MAUMELLE PLANNING COMMISSION

1. MSP-26-1 | MILLWOOD / ODOM MSP AMEND

2. SUB-25-9 | CCA-15 Development Plan

Re: SUB-25-9: CCA 15 PDP/PLAT/LANDSCAPE PLAN STAFF COMMENTS

Re: MSP-26-1 Master Street Plan Amendment of Siena Ridge, Maumelle, Pulaski County, Arkansas

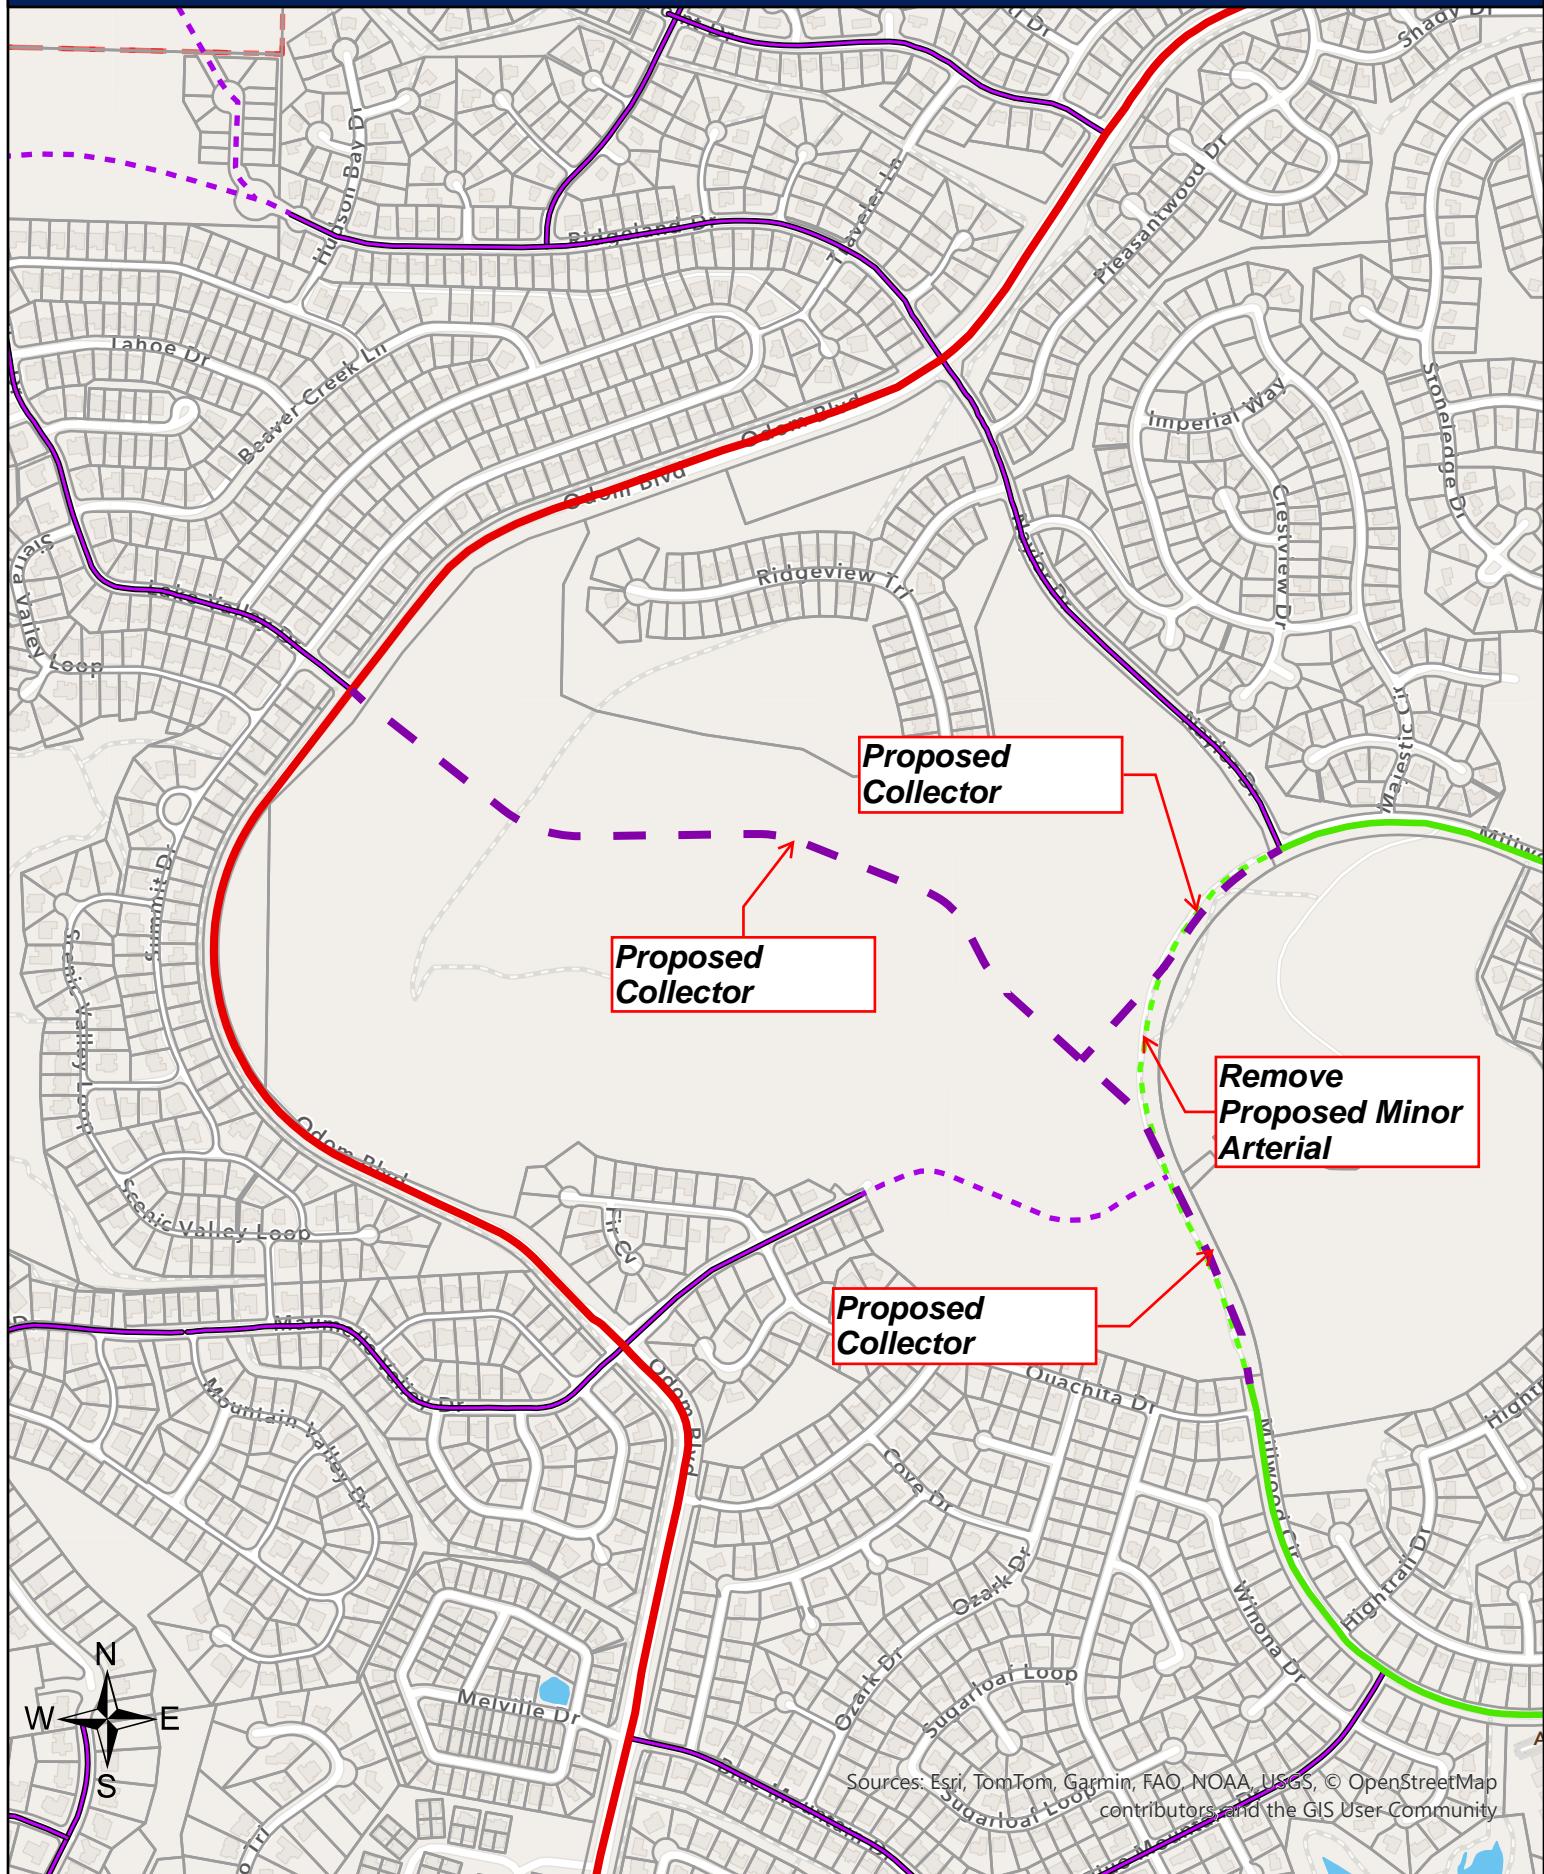
1) Street Network Connectivity & Mobility

The proposed connection improves direct access between Lake Valley neighborhoods and Town Center, supporting MSP objectives for efficient access and circulation.

2) Functional Classification (Collector vs. Arterial)

The proposed roadway is intended to serve as a connection distributing neighborhood traffic toward the Town Center street system—consistent with a **Collector** function rather than a through-movement **Minor Arterial**. Collector classification standards and ROW expectations should guide future design and dedication.

3) Traffic & Intersection Operations

A new connection will likely shift and concentrate turning movements at the endpoints (Lake Valley Drive and Millwood Circle), and at downstream Town Center intersections. Operational mitigation (stop control, turn lanes, etc.) may be needed depending on volumes.

5) Creek Corridor / Drainage Considerations

Because the alignment follows a creek system, implementation must address drainage, floodplain constraints (if present), erosion control, and any required easements—consistent with subdivision objectives protecting public safety and natural resources.

Staff recommends a **DO PASS** recommendation to City Council for the Master Street Plan Amendment, as shown on the submitted exhibit, subject to the following conditions/notes:

- 1. Collector Design Standard:** The corridor shall be designed and dedicated consistent with Collector (Class V) standards, including appropriate ROW and geometry.
- 2. Traffic Review:** Prior to construction approval (plat/site plan), require a traffic analysis/memo addressing endpoint intersections and needed operational improvements.
- 3. Drainage/Creek Protections:** Require drainage documentation, erosion/sediment controls, and any necessary easements due to creek corridor alignment.
- 4. Bike/Ped Accommodation:** Include an implementation note requiring bike/ped facilities (shared-use path/sidewalk or trail easement) connecting Lake Valley to Town Center where feasible.
- 5. ROW Dedication & Maintenance Plan:** To follow standard subdivision procedures for new development, contingent on City Engineer review and approval.

**PRELIMINARY DEVELOPMENT PLAN
GATEWAY PLAZA ADDITION
MAUMELLE, PULASKI COUNTY, ARKANSAS
ZONED COMMERCIAL PCD'**

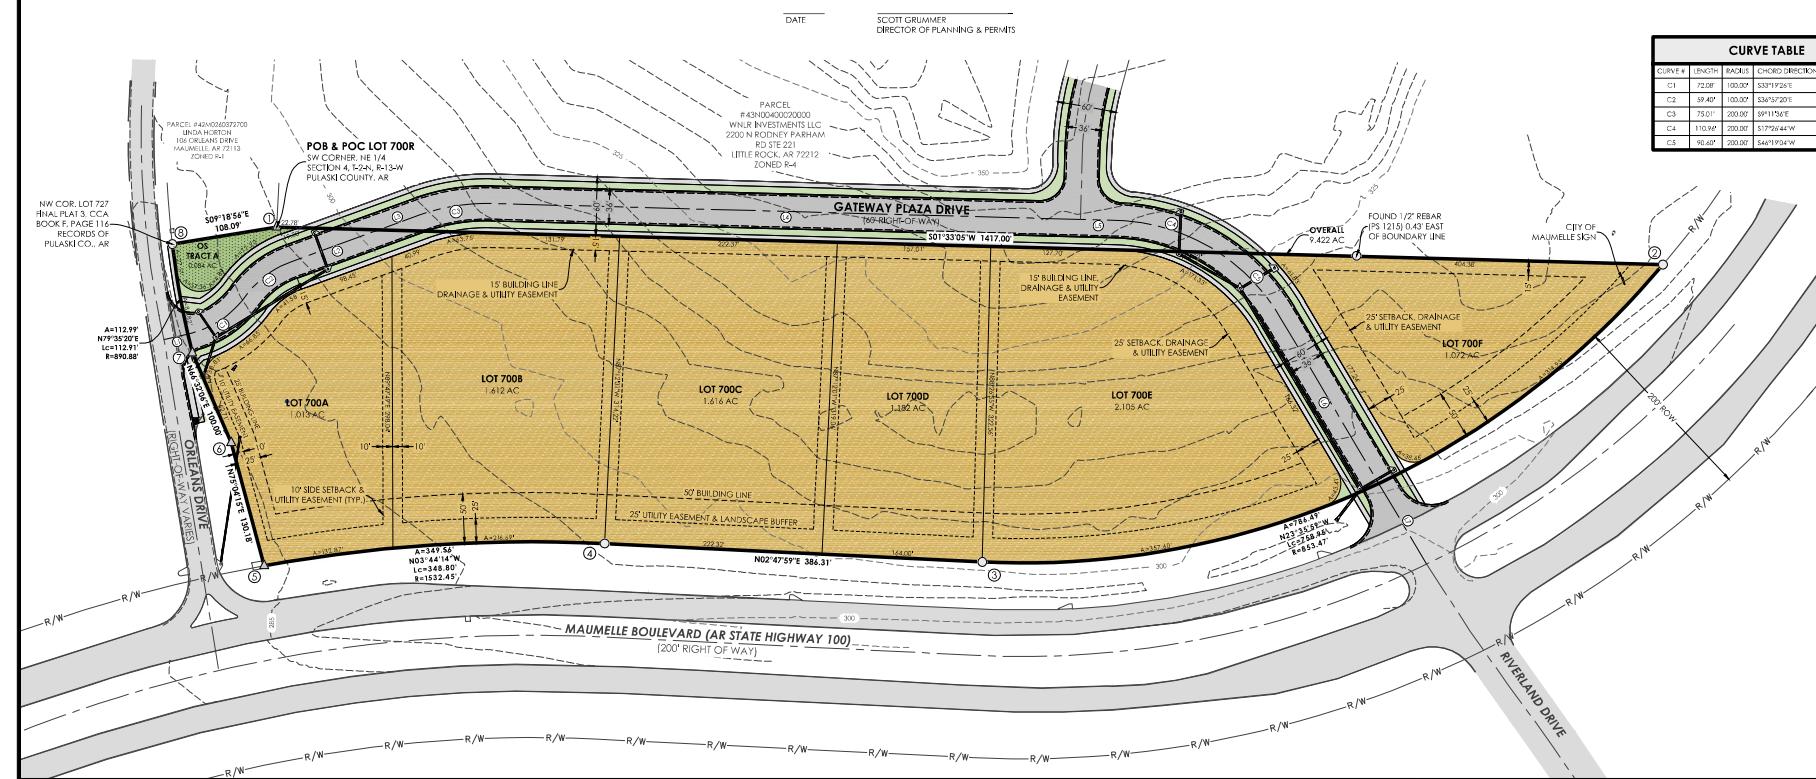
The preliminary plat should be corrected to show natural features/drainage information (flow direction and drainage areas) and the appropriate preliminary approval certificates (the current approval block shown is in a final-plat format). The frontage area currently labeled as a “landscape buffer” should be labeled and depicted as the required **Non-Clearing Setback** (and associated frontage treatment), with any approvals expressly contingent upon City Council adoption of proposed Ord. 1164. The bill of assurance submitted does not align with the PCD framework and will need to be revised with the final plat. Finally, the landscape plan needs to include the foundational items required at this stage—an inventory of existing protected trees with preserve/remove designations (unless this is being deferred to the individual lot submittals), a complete plant schedule (names, quantities, spacing, and sizes), and grading/contour information—so the Highway 100 frontage standards and the non-clearing setback can be consistently implemented as individual lots develop.

Checklist item	Code citation	Complies	Plan reference / staff notes
1	Narrative: general character/rationale statement	Sec. 94-452(1)(a)	No	Not provided in PDP
	Quantitative data: uses + floor area by use	Sec. 94-452(1)(b)2	Partial	“PCD” noted, with uses and floor area by individual lot submission
	Quantitative data: building coverage / FAR	Sec. 94-452(1)(b)3	Partial	Expected with individual lot submission, BUT Min/Max % should be provided.
	Quantitative data: open space by type	Sec. 94-452(1)(b)4	Partial	Common open space % shown; “by type” not broken out.
	Circulation (parking/service/loading/access points)	Sec. 94-452(1)(c)4	Partial	Road length shown; parking/loading/access points to be provided with individual lot plan submittals.
2	Pedestrian circulation	Sec. 94-452(1)(c)5	No	Not provided; proposed Hwy 100 frontage pathway?
	Perimeter treatment + relationship to surrounding uses	Sec. 94-452(1)(c)6	Partial	See Landscape Plan for Concept Intent; Plat & Dev Plan “Landscape buffer” should be “25’ Landscape buffer and non-clearing setback per Sec. 90-84”; This item is contingent on Approval of Ord. 1164.

Preliminary Plat requirement	Correct code citation	Status (from PLP sheet)	Plat reference / staff notes
	Contours/topography (5' or 2' intervals depending on slope)	Sec. 70-101(d)(1)	Partial	Contours should be shown on Plat, but not on Dev Plan
	Proposed design: streets/alleys/sidewalks, street names, lot lines & approx. dimensions, easements, open space/dedications, nonresidential land	Sec. 70-101(d)(2)	Partial	Lots/streets/easements shown; sidewalks with individual plan submissions; dedications not detailed (pending NLR/Maumelle review)
5	Natural features / drainage info (flow direction; drainage area noted)	Sec. 70-101(d)(4)	No	Must be shown on Plat
	Storm drainage analysis (must handle ≥ 50-year rainfall)	Sec. 70-101(d)(5)	Partial	To be submitted with individual plan submittal
	Preliminary storm drainage plan (easement dimensions + typical ditch sections)	Sec. 70-101(d)(9)	Partial	To be submitted with individual plan submittal

Engineering analyses (street cross-sections/profiles; floodplain analysis where applicable)	Sec. 70-101(e)	Partial	Contingent on City Engineer Review and approval
Preliminary plat certificates (Surveying / Engineering / Approval)	Sec. 70-101(f)(1)(a-c)	Partial	PLP has surveying certificate; City approval block shown is Final Plat (not Preliminary)
Draft bill of assurance submitted with preliminary plat	Sec. 70-101(f)(3)	Partial	CCA BOA provided does not apply to PCD; revised required with Final Plat

GATEWAY PLAZA ADDITION
MAUMELLE, PULASKI CO., ARKANSAS
FOR: CYPRESS BAY DEVELOPMENT LLC
LANDSCAPE PLAN CONCEPT

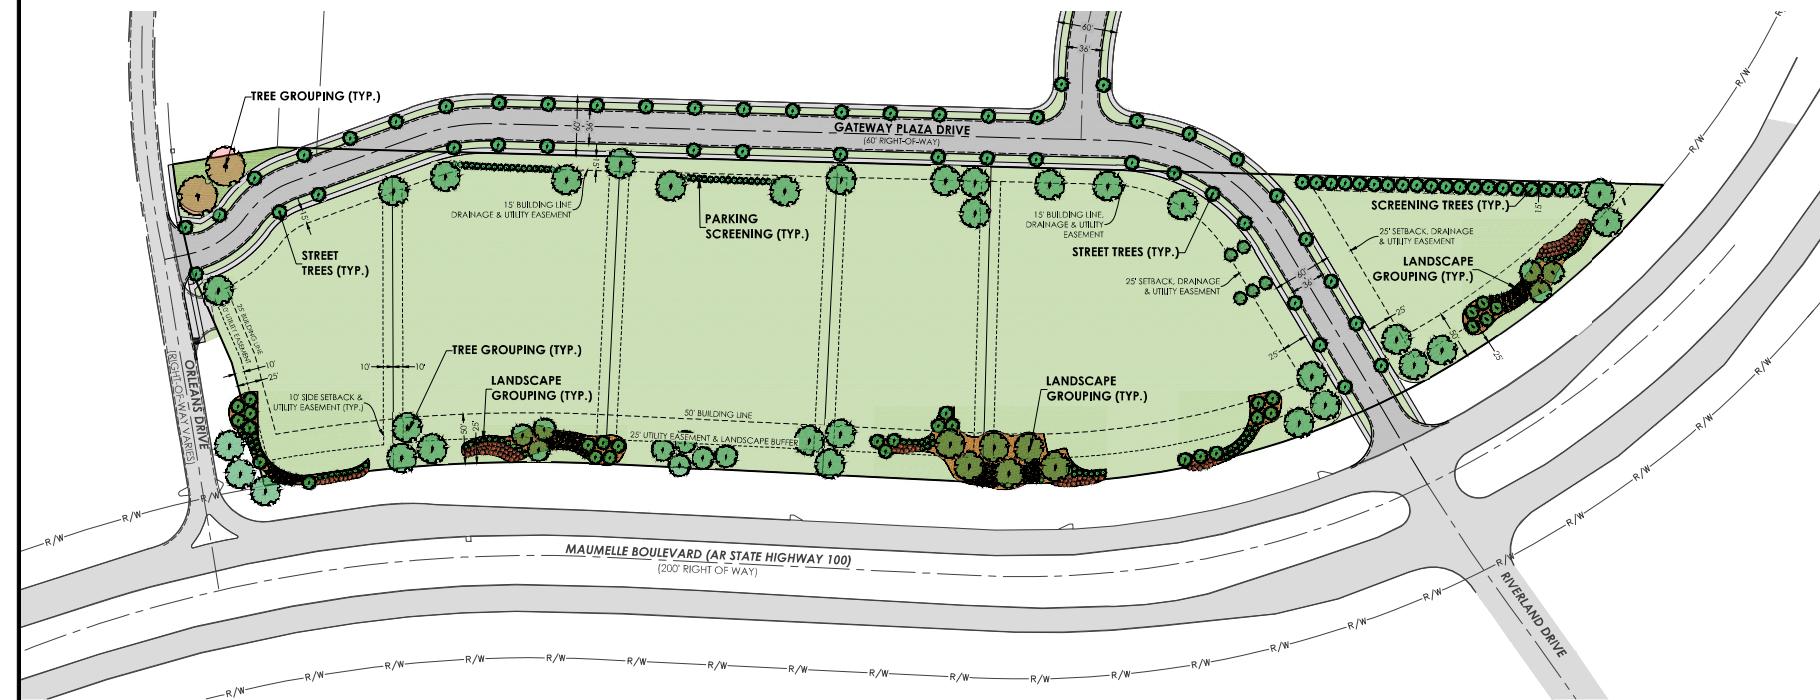
2) Landscape Plan Checklist (Chapter 90) — using proposed Ord. 1164 amendments
A. General Ch. 90 requirements

Landscape plan requirement	Code citation	Status	Plan reference / staff notes
	Existing/proposed lighting, parking, drives, sidewalks, curbs, etc.	Sec. 90-39(c)(3)	Partial	“Parking” and general layout labels appear; lighting/sidewalk/drive data with individual plan submittals.
	Existing traffic controls/utilities/etc. in ROW	Sec. 90-39(c)(5)	Partial	To be shown on individual plan submittals
6	Existing isolated trees ≥6" caliper + tree masses; designate preserve/remove	Sec. 90-39(c)(6)	No	LSP shows proposed “street trees/tree groupings,” but no existing-tree inventory/retain vs remove to be shown on master or individual plans?
7	Proposed plant materials w/ botanical/common name, quantity, spacing, size	Sec. 90-39(c)(7)	No	No plant schedule shown (only “typ.” labels)
8	Decorative screen: exterior elevation + wall section (if used)	Sec. 90-39(c)(8)	No/NA?	Not shown (previous mention of retaining walls)

9	Existing/finished grade spot elevations and/or contours	Sec. 90-39(c)(9)	No	Not shown
	Irrigation plan w/ spray radii	Sec. 90-39(c)(10) (as amended)	Partial	Irrigation sleeve notes provided; spray radii with individual plan submittals
10	Hwy 100 frontage: identify existing trees ≥6" dia. within 50' of ROW; caliper + preserve/remove	Sec. 90-39(c)(11) (Ord. 1164)	No	Not provided; indicate whether with individual plan submittals or show on this Landscape Plan

Street landscaping required along ROW side of vehicular use area	Sec. 90-37(b)(1) (Ord. 1164)	Partial	LSP indicates street trees, quantities/spacing with individual plan submittals
Hwy 100 frontage landscaping strip ≥15' beyond vehicular encroachment	Sec. 90-37(b)(2)a (Ord. 1164)	Partial	Vehicular encroachment line to be submitted with individual plans
Planting screen/durable barrier; Hwy 100 requires 36" height	Sec. 90-37(b)(4)a (Ord. 1164)	Partial	Barrier detail to be shown with individual plan submittals
Hwy 100: one tree per 30 linear feet (staggered)	Sec. 90-37(b)(5)a (Ord. 1164)	Partial	Concept Intent notes compliance with Maumelle minimum standards; to be reviewed with individual plan submittals
Road setback lines (tree cutting restriction) — commercial/industrial: 50' from Hwy 100 ROW	Sec. 90-84(1) (Ord. 1164)	No	LSP shows "50' building line" and "25' utility easement & landscape buffer". Applicant should clearly depict and label the non-clearing setback line .
